MY3 Monitoring Report

Owen Farms Mitigation Site
Transylvania County, NC

Re: MY3 Monitoring Report Comments
Owen Farms Stream and Wetland Mitigation Site
French Broad River Basin; CU# 06010105 – Transylvania County
DMS Project ID No. 100064
Contract No. 7532
SAW-2018-01165

Response to DMS Comments

CURRENT CONDITIONS PLAN VIEW
OWEN FARMS MITIGATION SITE
 FIGURE 2.2

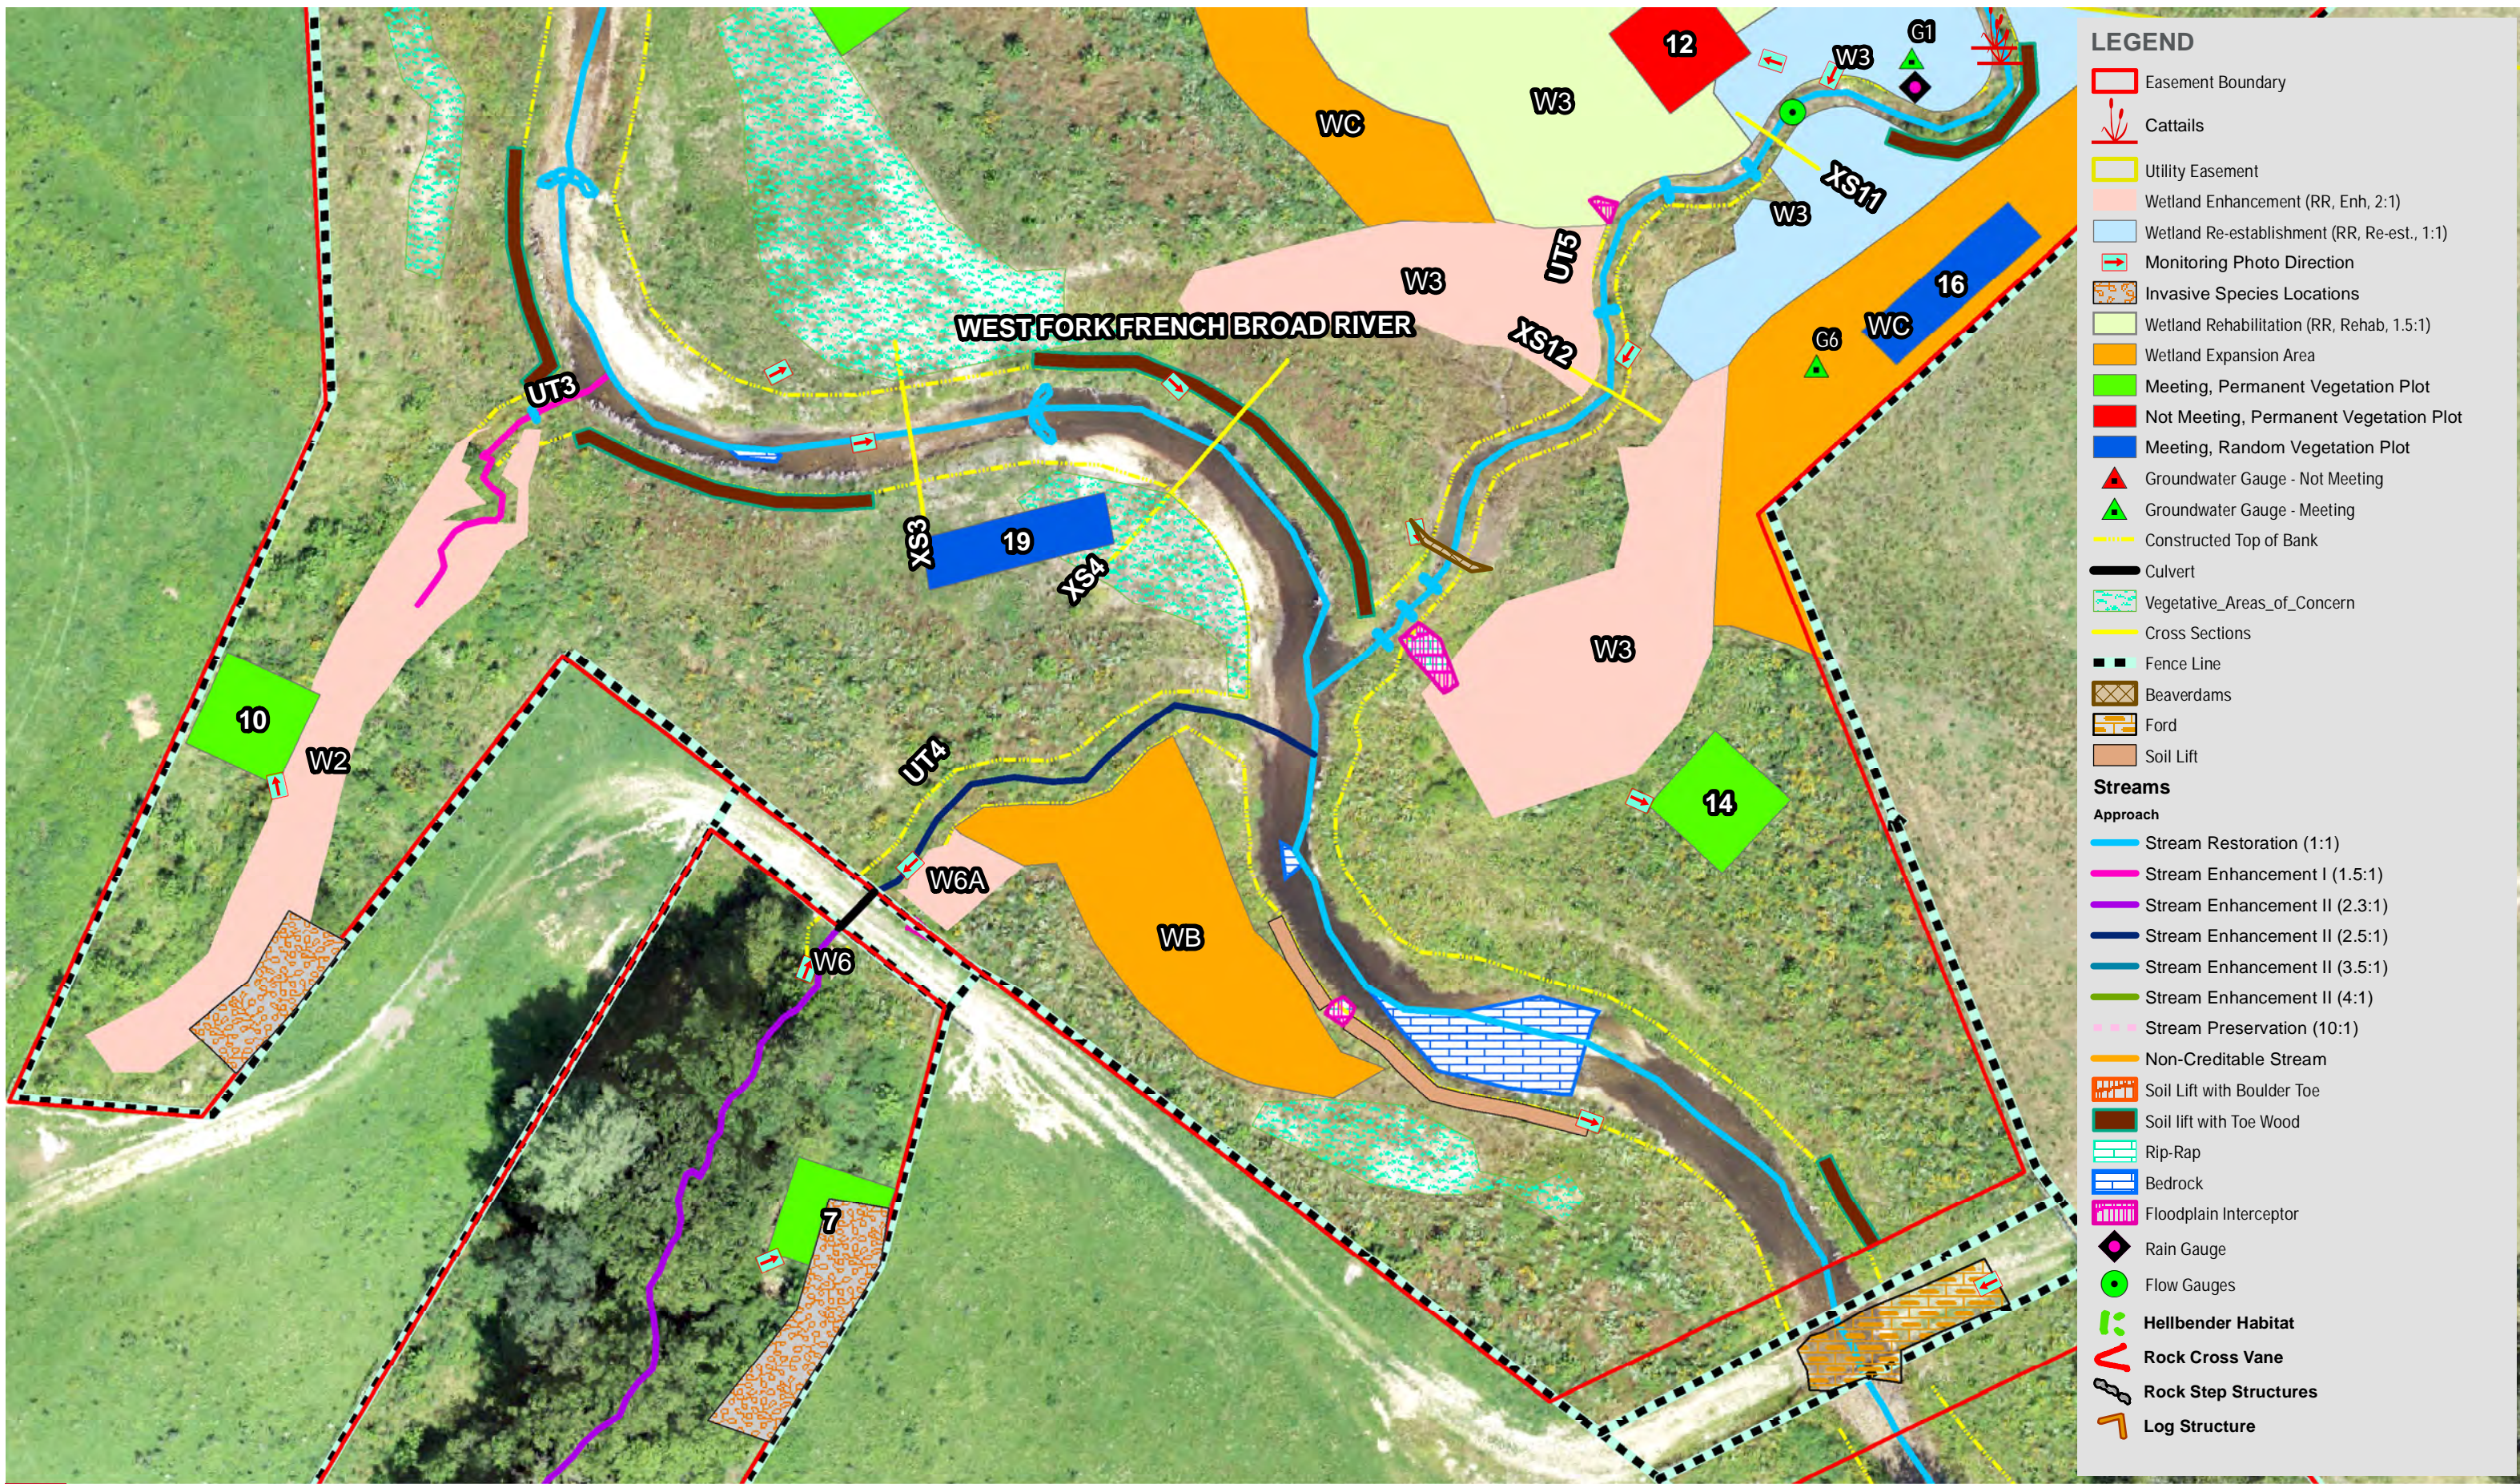
7. IRT noted that Figure 2.2 of the CCPV was not accurate (it is a duplicate of Figure 2.3), and requested that HDR correct for MY3 report.

Figure 7.4 UT 8 Flow Depth

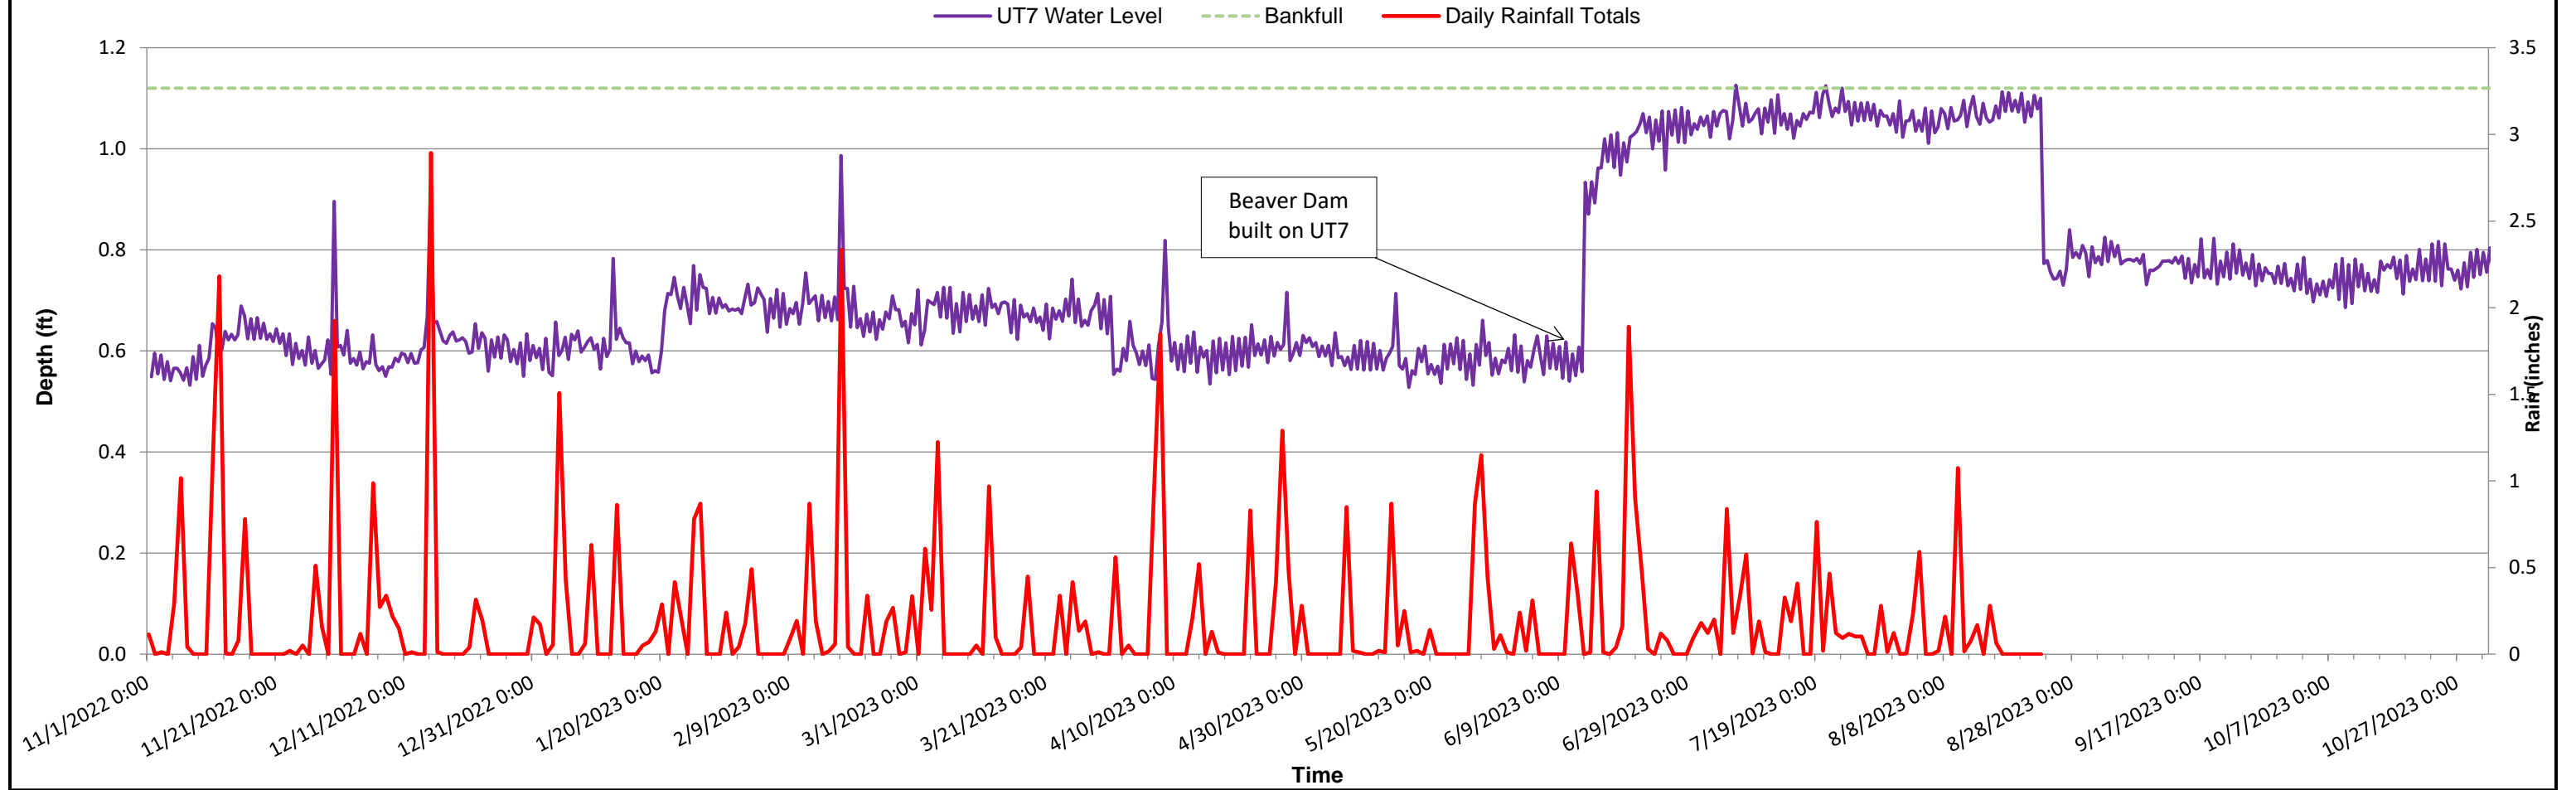
7: Figure 7.4: Please update the “Daily Rainfall Totals” line in the graph legend. It currently reads “Series1”. *Graph legend title has been updated.*
